Response to Submissions
in support of a
Section 75W Modification of
Project Approval PA08_0212

New Berrima
Clay/Shale Quarry

R.W. CORKERY & CO. PTY. LIMITED

September 2015

Figure 5
INDICATIVE FINAL LANDFORM
CROSS SECTIONS

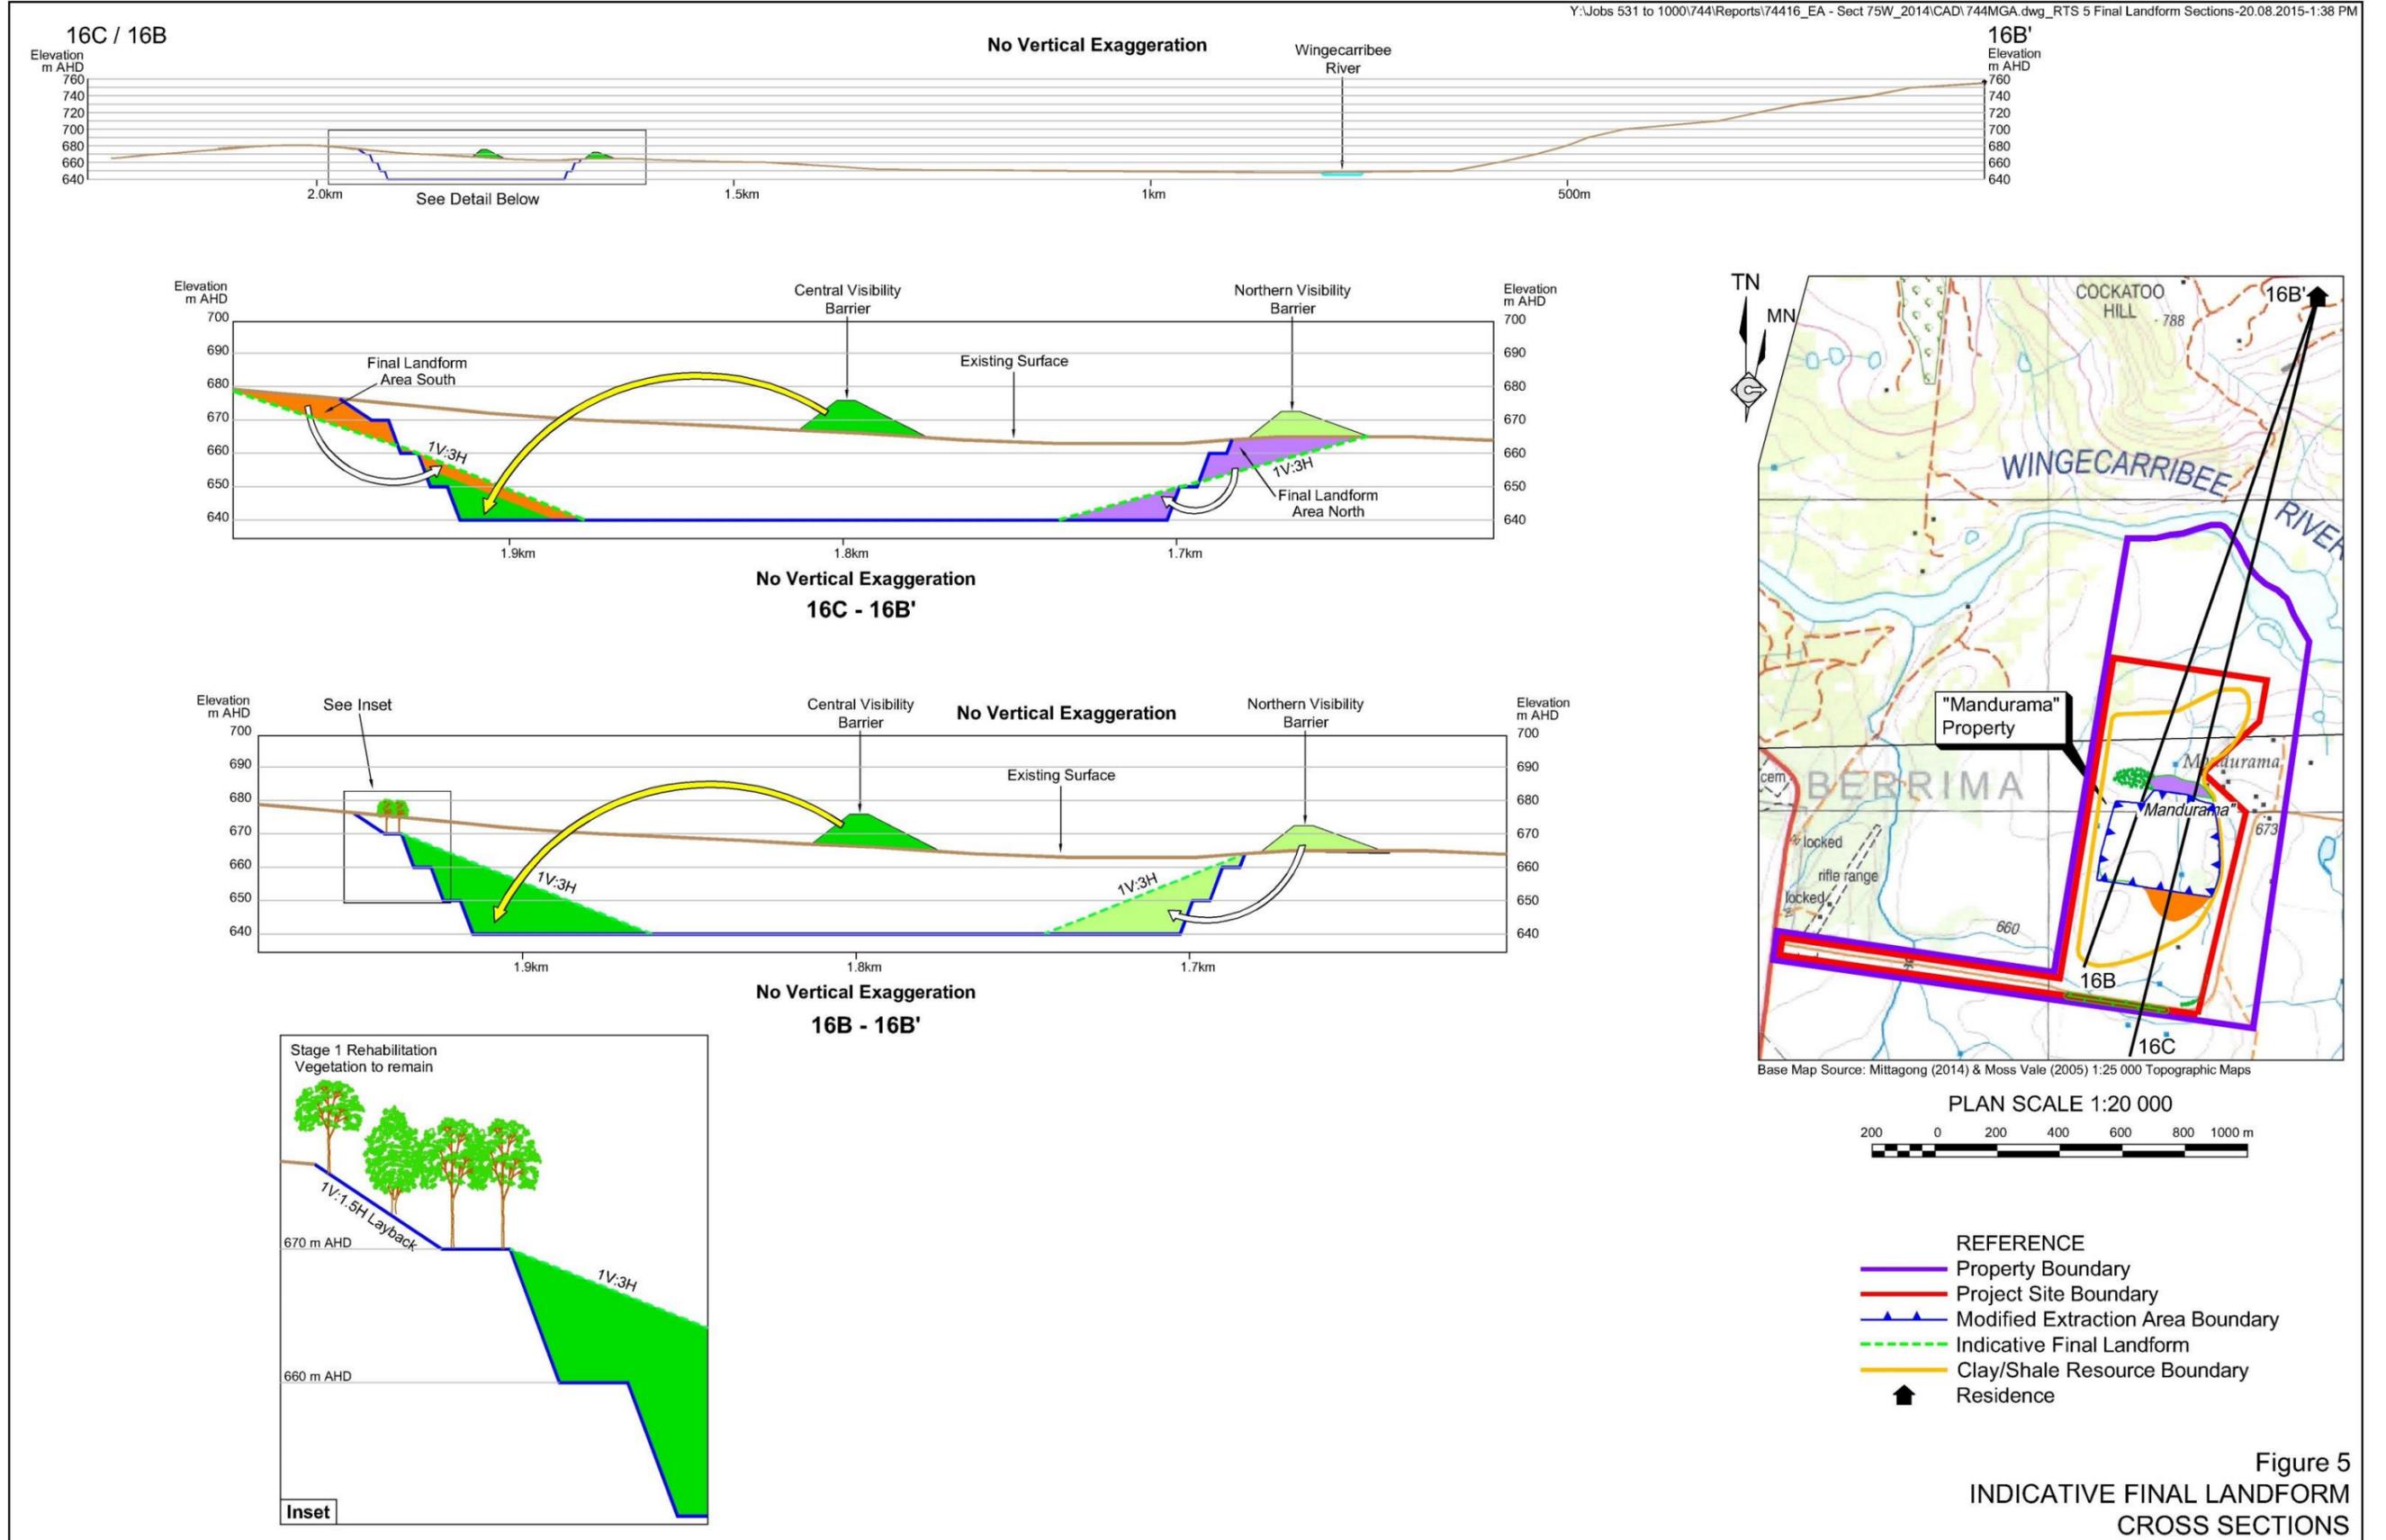
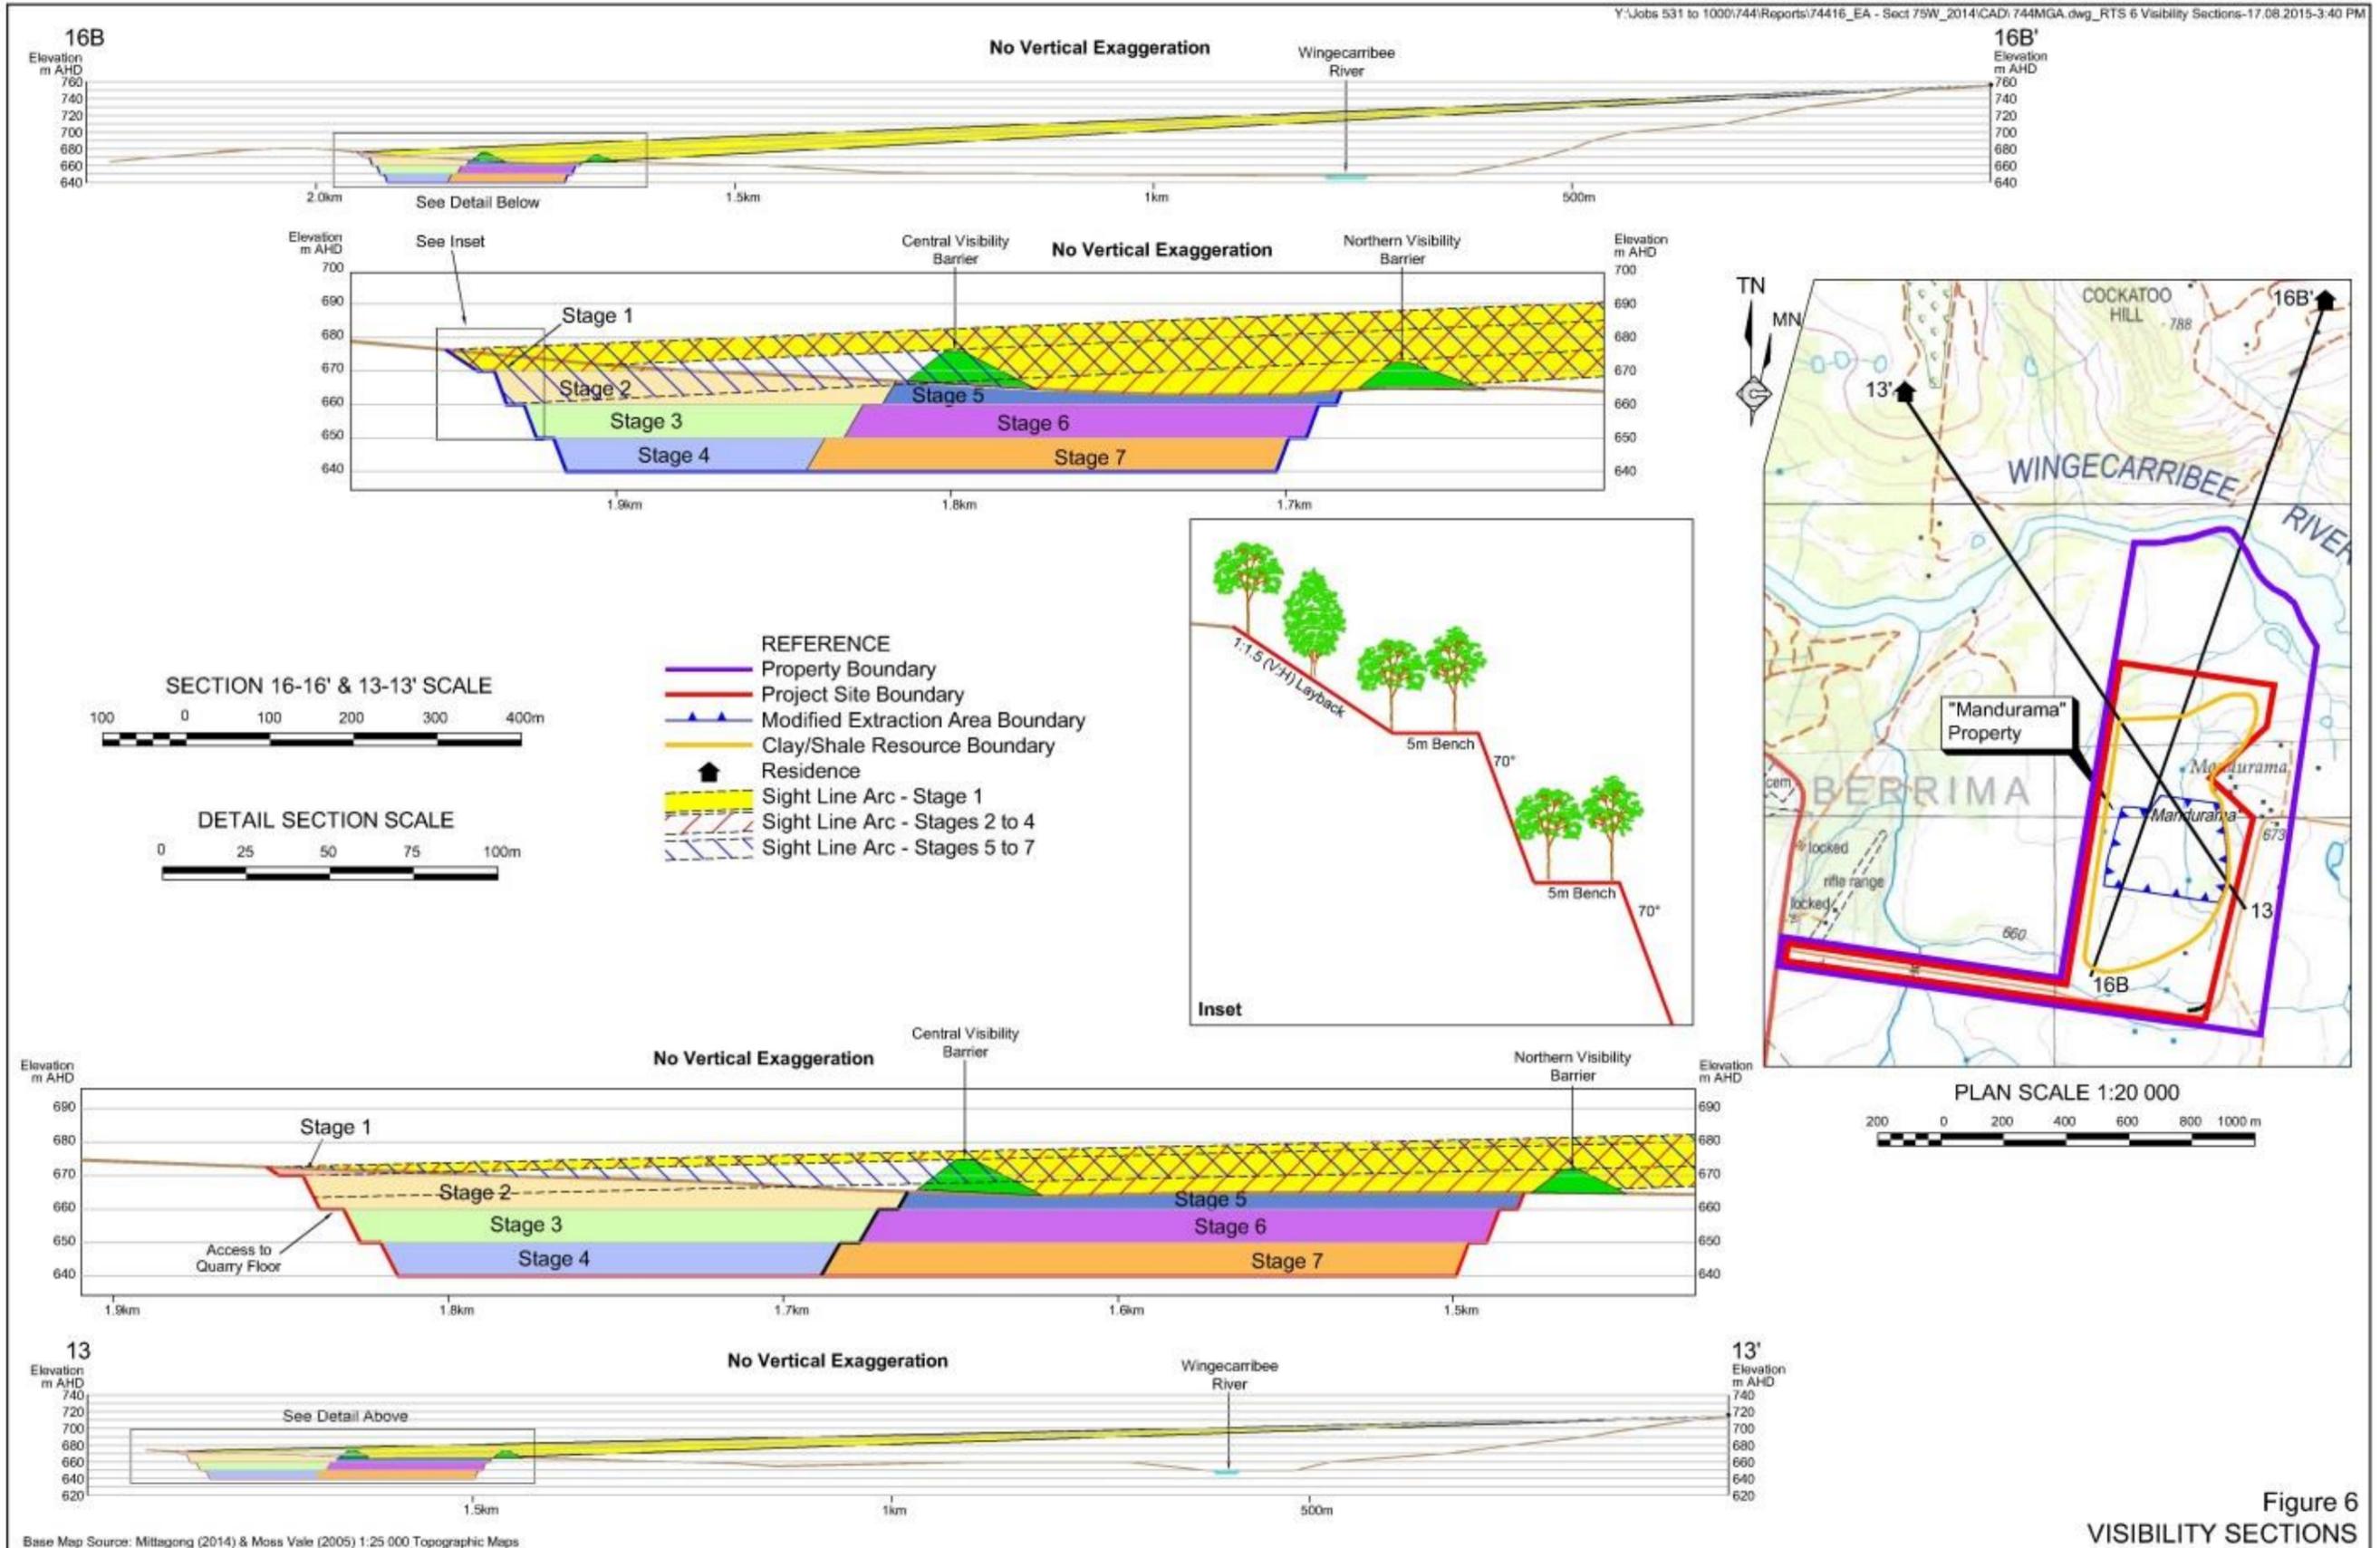
Representative Comment(s)

Figure 4 presents a plan view of the revised final landform and **Figure 5** presents sections through the revised final landform. The revised final landform now incorporates final undulating slopes of approximately 1:3 (V:H), utilising material available from the Central and Northern Visibility Barriers and some recovery of material from the southern side of the extraction area and the footprint beneath the Northern Visibility Barrier at the end of the Quarry life.

- On the western section of the extraction area void at the end of Stage 4 (see cross section 16B' – 16B on **Figure 5**), the material would be placed up to the approximate level of the 670m bench, shaped to a final landform of approximately 1:3 (V:H) and stabilised with a permanent grass vegetative cover. The 670m bench by this stage of the modified Proposal would have established (15 year old) trees and shrubs that would have been planted following the commencement of Stage 1 operations and would remain *in situ* on that bench. No further activities would be undertaken in this section of the Quarry.

- On the eastern section of the extraction area void at the end of Stage 4 (see cross section 16C – 16B on **Figure 5**), material within the Central Visibility Barrier would be placed against the wall of the extraction area, up to the 660m AHD bench and shaped to create an interim undulating slope of approximately 1:3 (V:H).

Plate 2 : View to the south towards the proposed extraction area from Residence 16B with an indicative representation of the Central Visibility Barrier

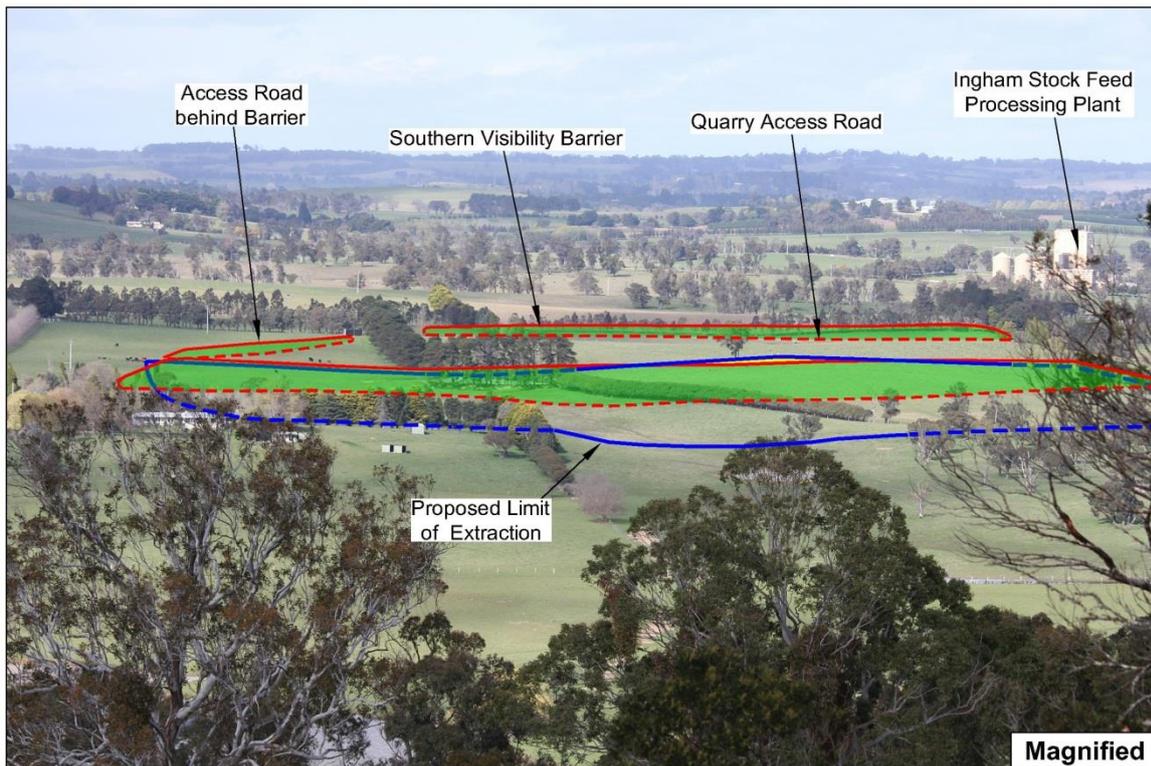
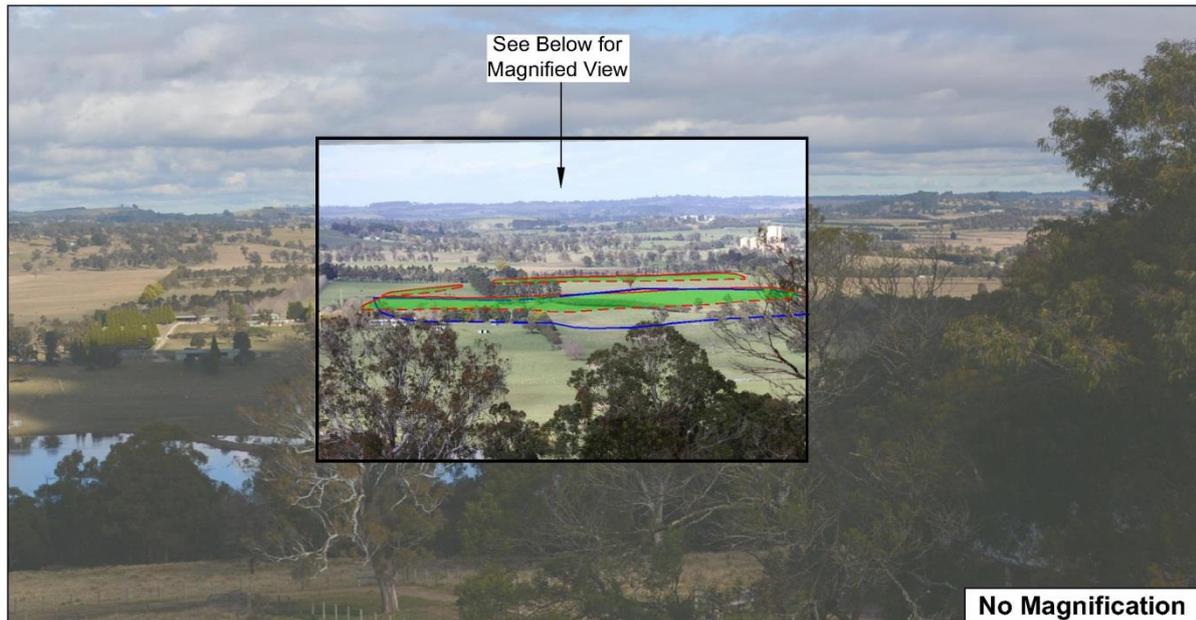
Representative Comment(s)

Plate 2 displays the location / approximate height of the Central Visibility Barrier together with the Southern Visibility Barrier and a new proposed access road barrier leading from the exit from the extraction area through the existing trees on the nearby ridgeline. The indicative presentation is presented with and without magnification.

It is stressed that magnified views presented in **Plates 2** and **3** are views intended to assist the owners of Residence 16B to better understand the effectiveness of the visibility barriers with the Project Site. When assessed in conjunction with the wider non-magnified view, i.e. **Plate 1**, the area of visual impact and relative heights of the barriers would be considerably less.
